Subject: Public Comment re. Spieker Proposal

This is Public Comment on the Draft EIR for County File # CDGP20-00001, CDRZ20-03255, CDMS20-00007, CDDP20-03018, & CDLP20-02038, The Spieker Senior Continuing Care Retirement Project

Map Portfolio—Save Seven Hills Ranch

4 Floor Levels Map

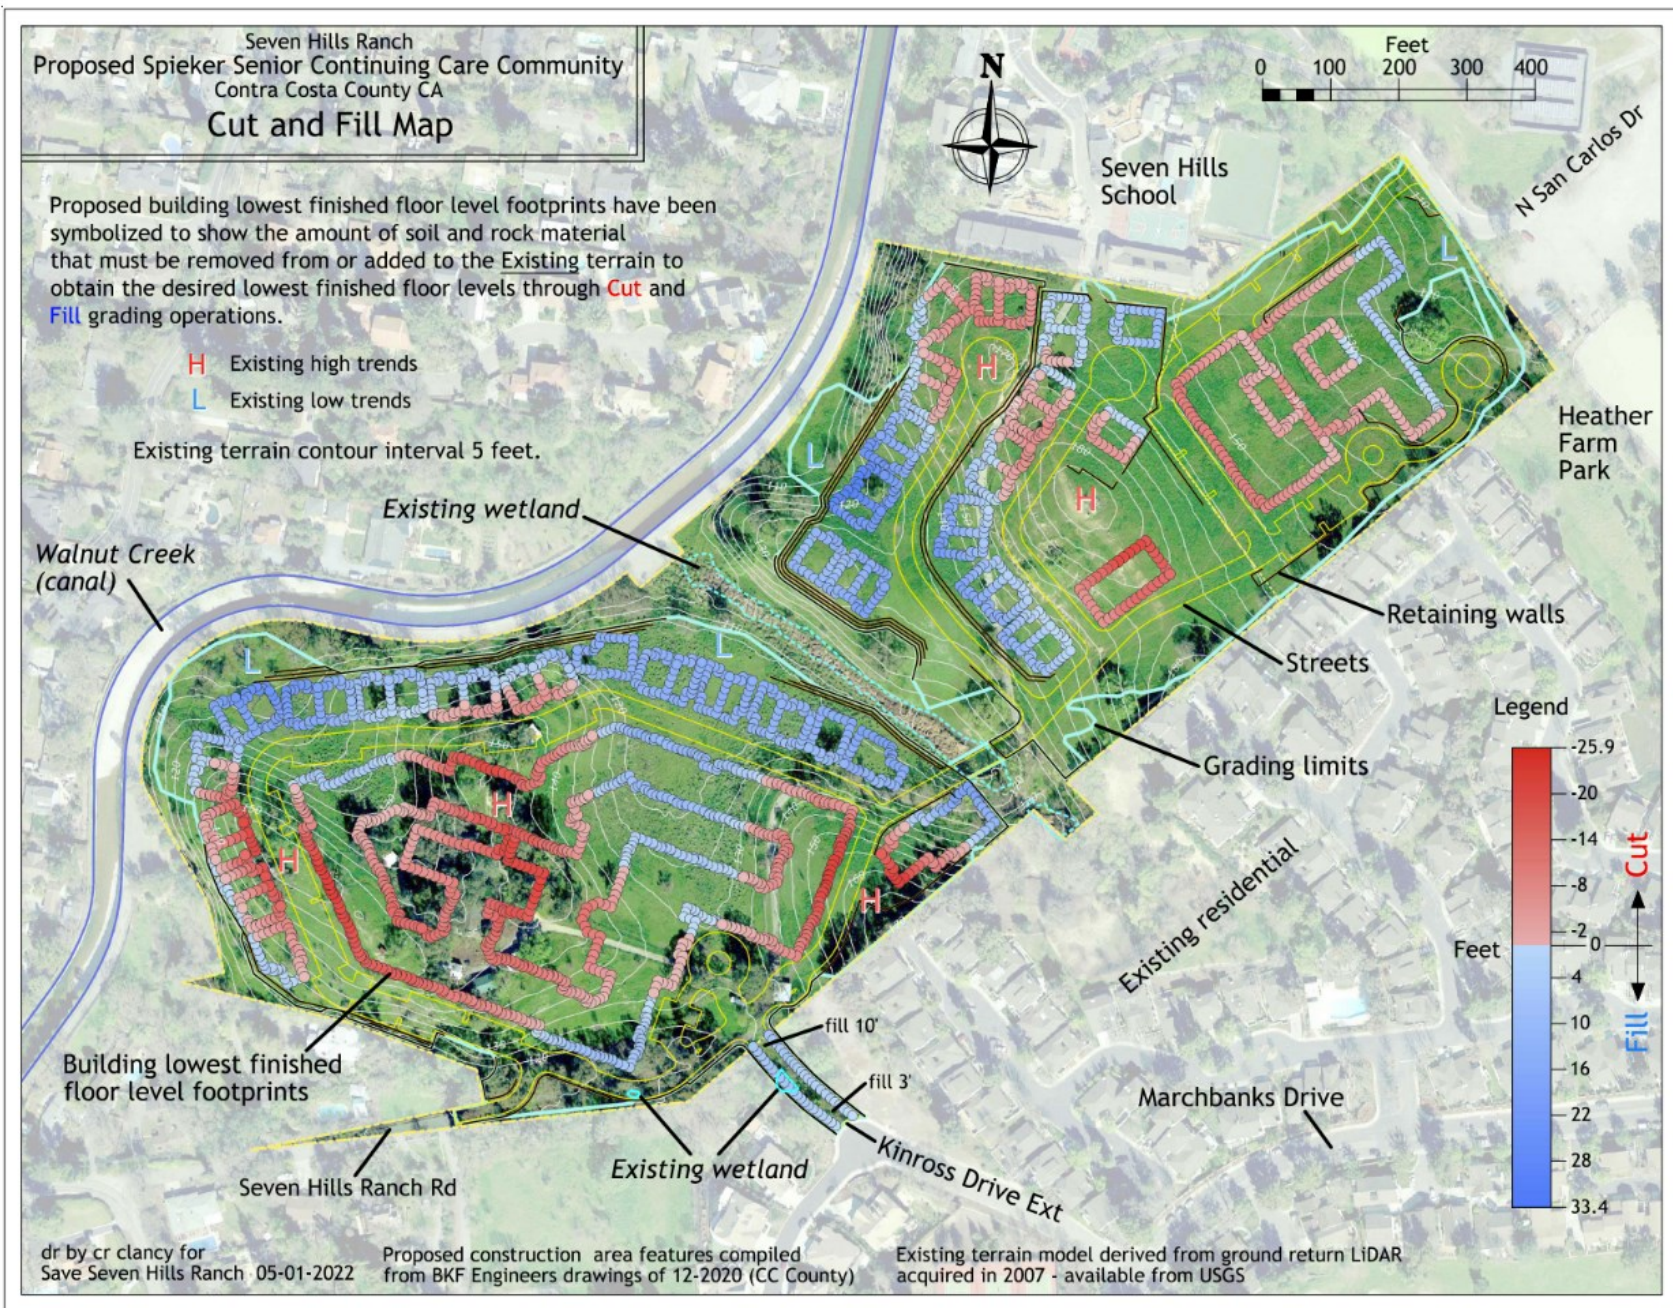
This map illustrates the contrast between the developer's and the DEIR's statements and implications that the project is designed for environmental compatibility between the existing rolling terrain and the design proposed. In fact, this map indicates that the entire western hills would be leveled to create a platform for the IL Building and surrounding villas. The true proposed finished floor levels have been color-coded to show how far above sea level they are planned to be.

5 Cut and Fill Map

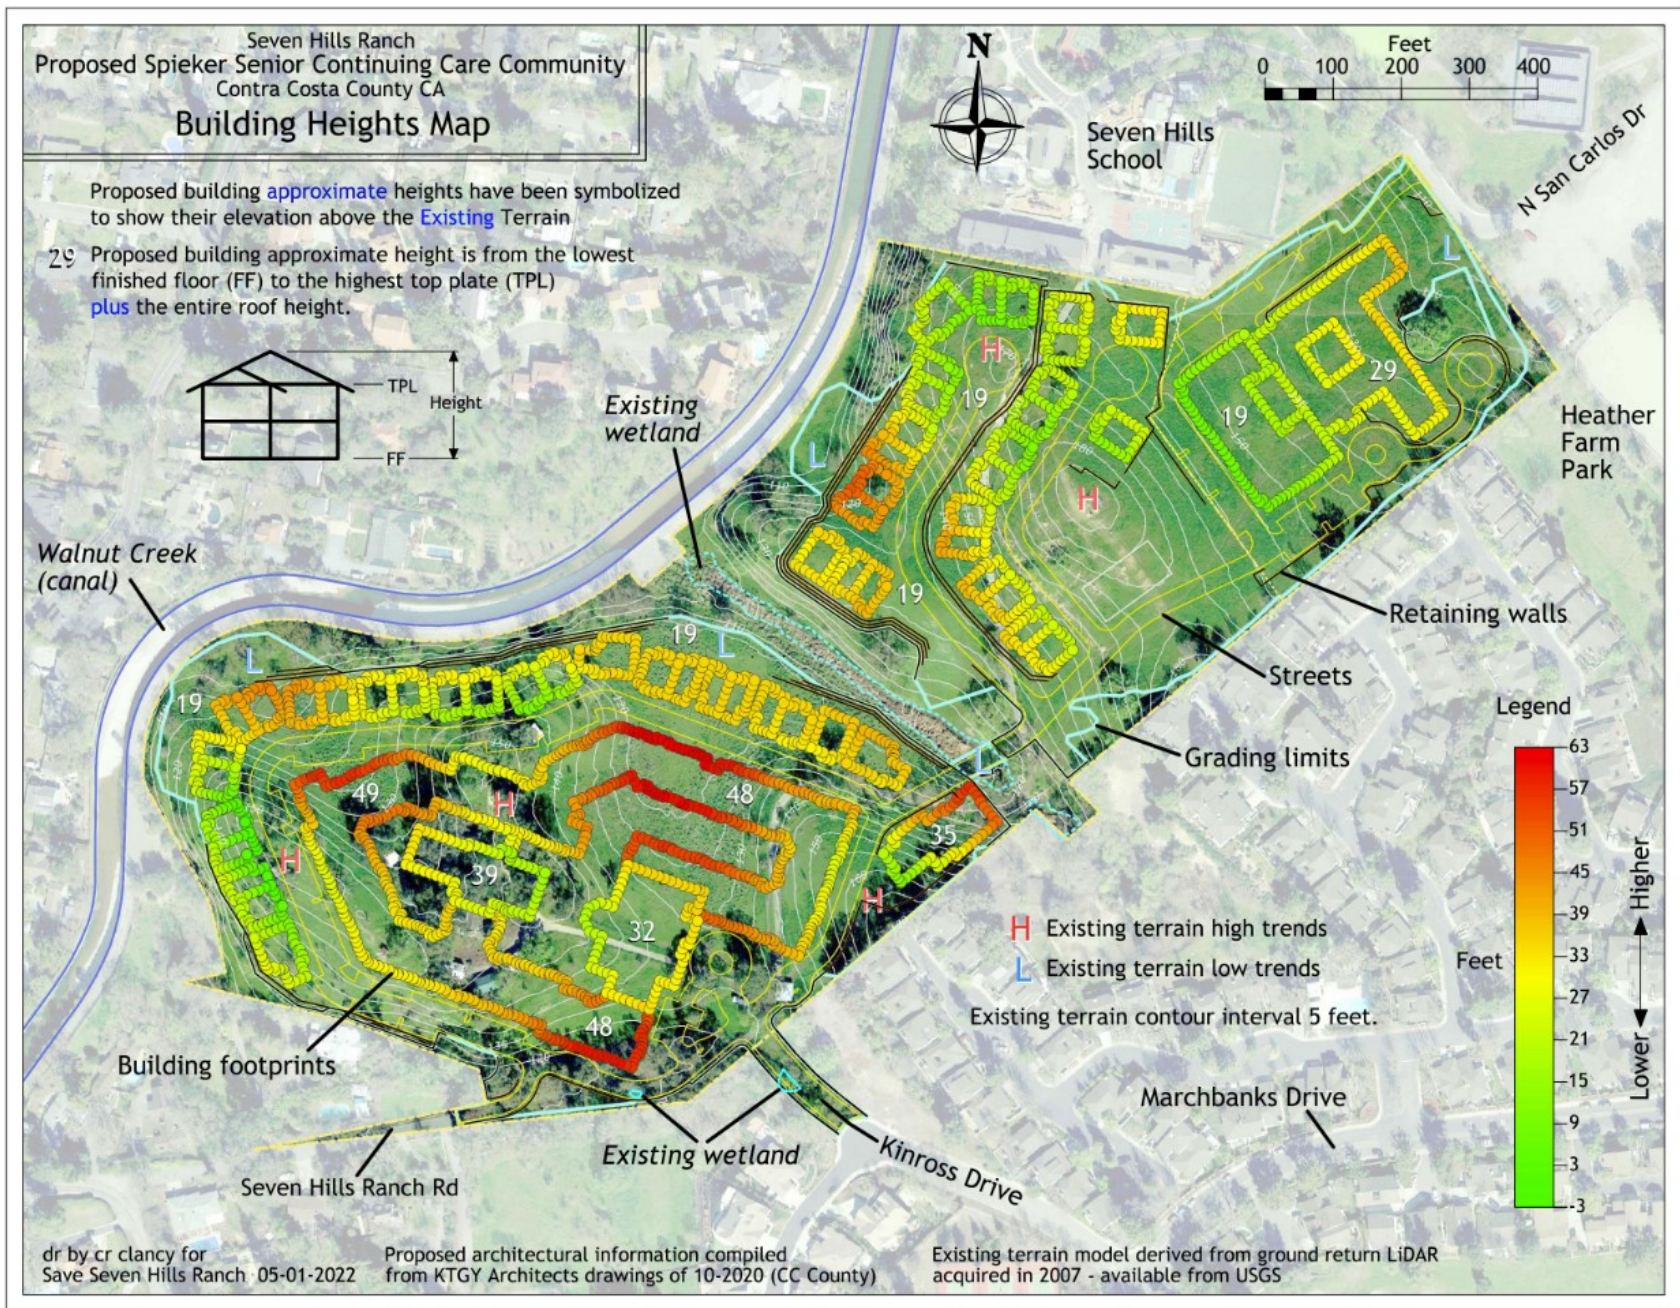
This map illustrates the extensive cut and fill grading that would be required to create the platforms for the proposal's various buildings. The proposed design's environmental incompatibility with the existing terrain is graphically and clearly represented. Cut and fill values have been color-coded in order that cut and fill can be easily differentiated and their magnitudes compared. Many of the site's locations for cutting operations would involve bedrock removal, a fact that has not been addressed in the developer's proposal or the DEIR.

6 Building Heights Map

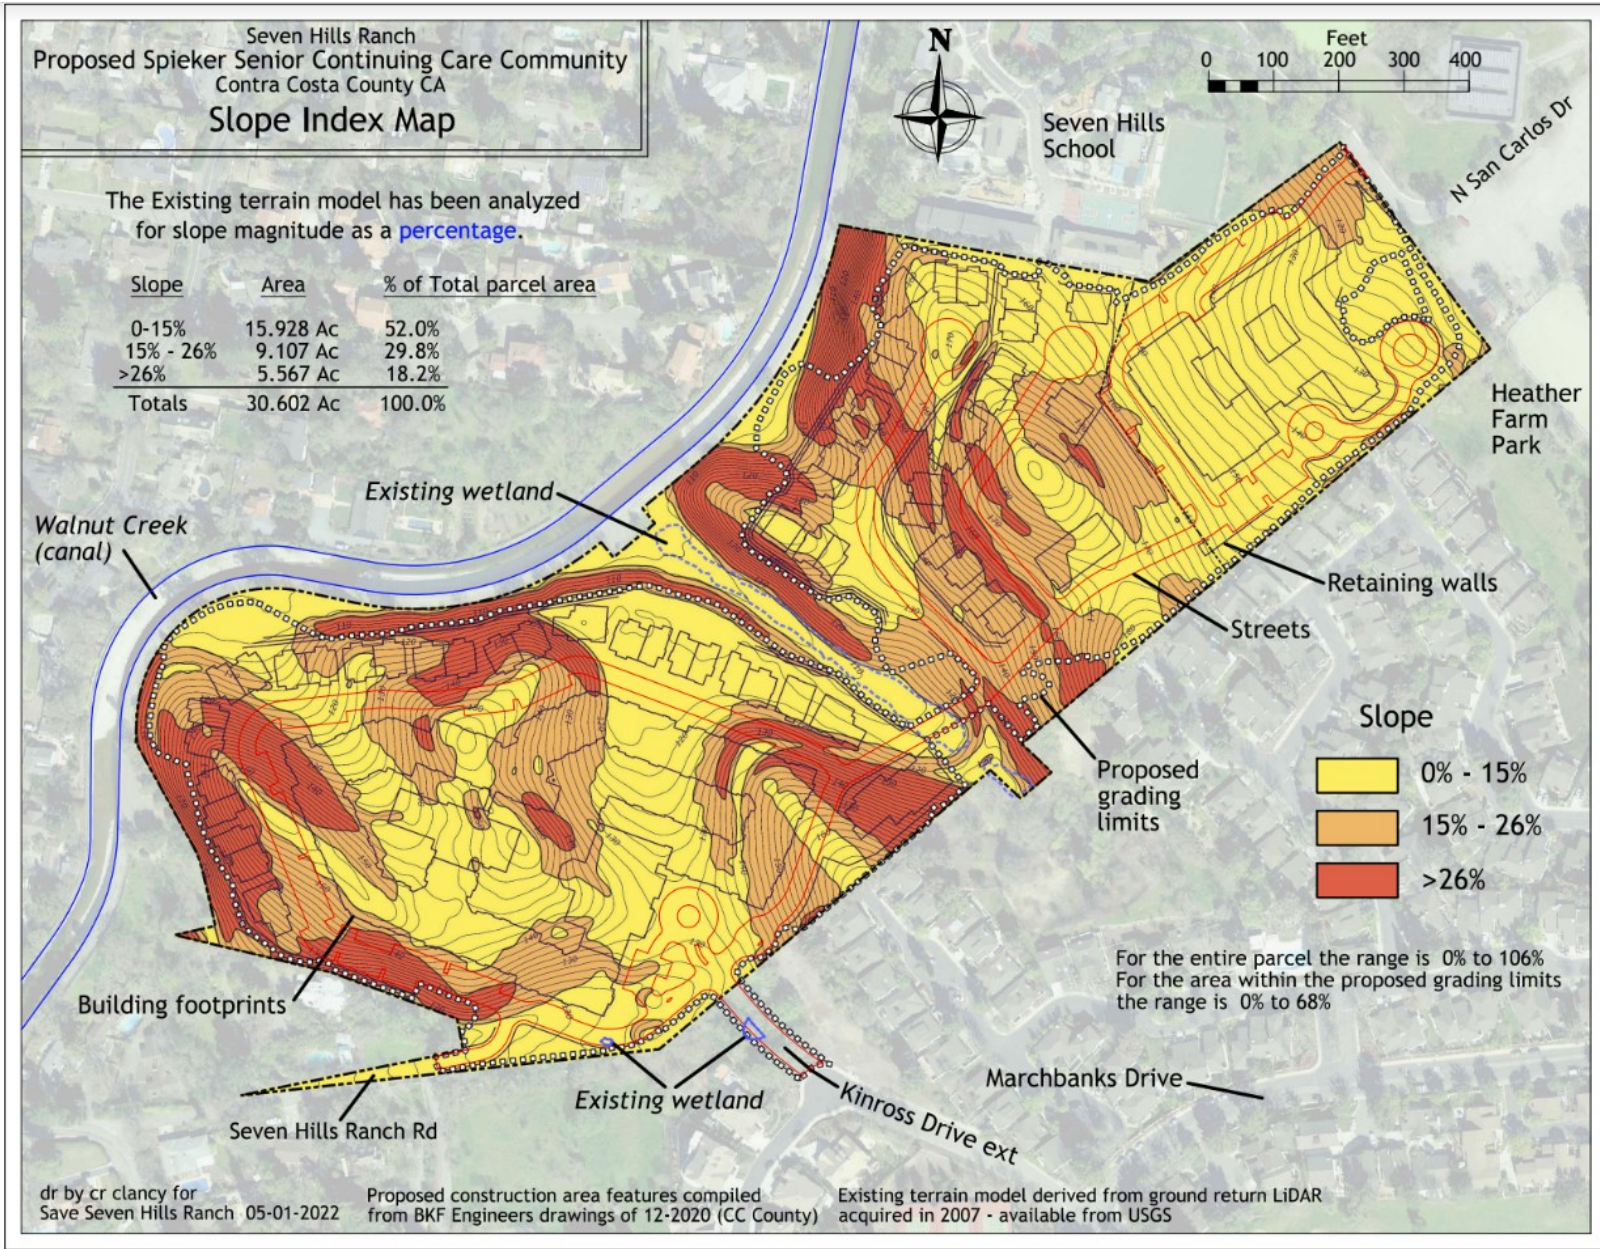
This map indicates how far above the existing terrain the proposed rooftops would be. The site is currently undeveloped with the exception of one single-family residential building and a few small outbuildings. The addition of the proposed buildings will dominate the site.

9 "Adirondack Hill" Detail Map; Slopes, Wetlands Bridge

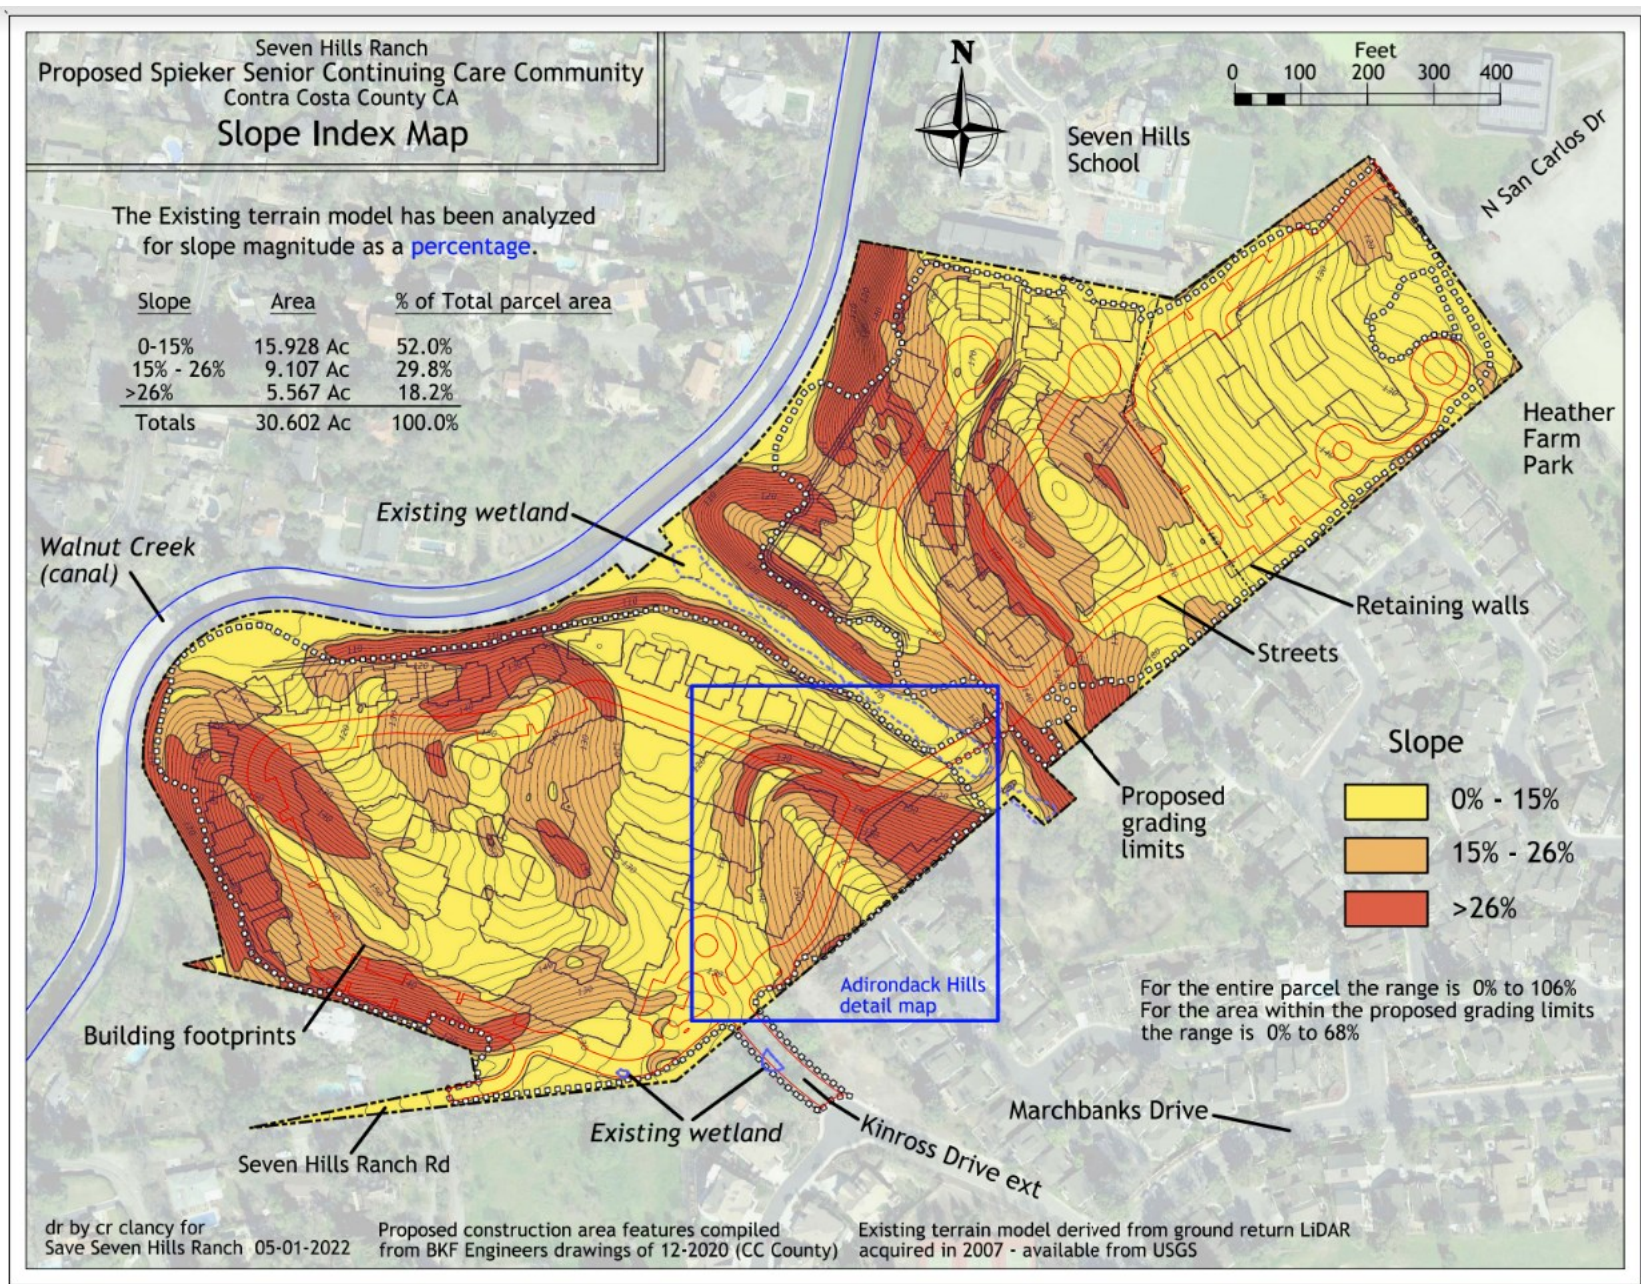
"Adirondack Hill" is the name given here for the area at the end of Adirondack Drive in the adjacent Heather Farm HOA development. The proposed development plans call for cuts into this hill to create platforms for the Maintenance Building and the southeastern end of the IL Building. This map reveals that slope codes and noise codes have been disregarded. Additionally, proposal does not account for the fact that this extreme grading would involve bedrock removal exceedingly close to existing residences. The map also indicates where a proposed bridge over the Central Wetland would be located, how high its abutments would be, and how close the grading and construction would be to the wetland. The DEIR must clearly state these impactful and significant realities. See Locator Map next page for detail orientation.

11 CCCo Development Constraints, 26% slope / Alternatives Map

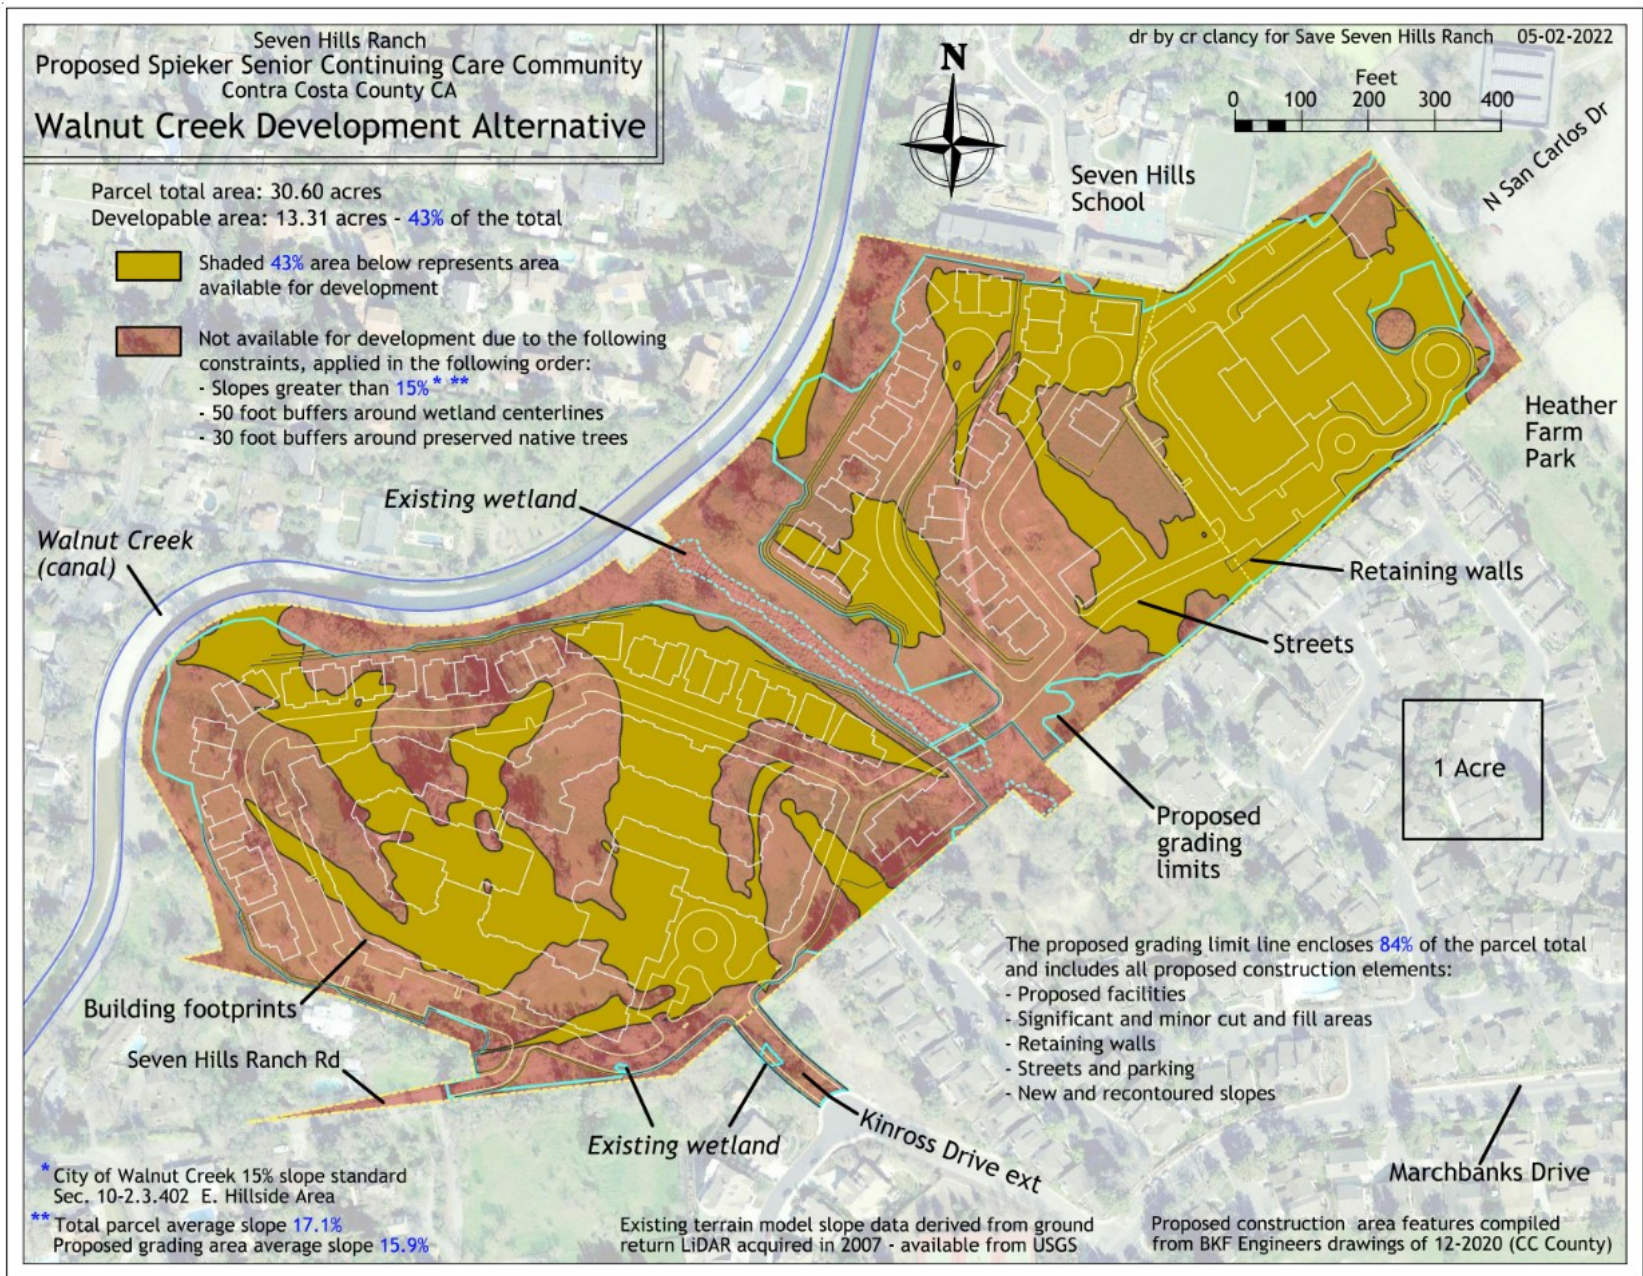
This map shows how much developable land would be available if the Contra Costa County 26% slope code and a limited set of other constraints related to trees and wetlands were adhered to. The map can help visualize realistic and environmentally respectful Alternative development possibilities.
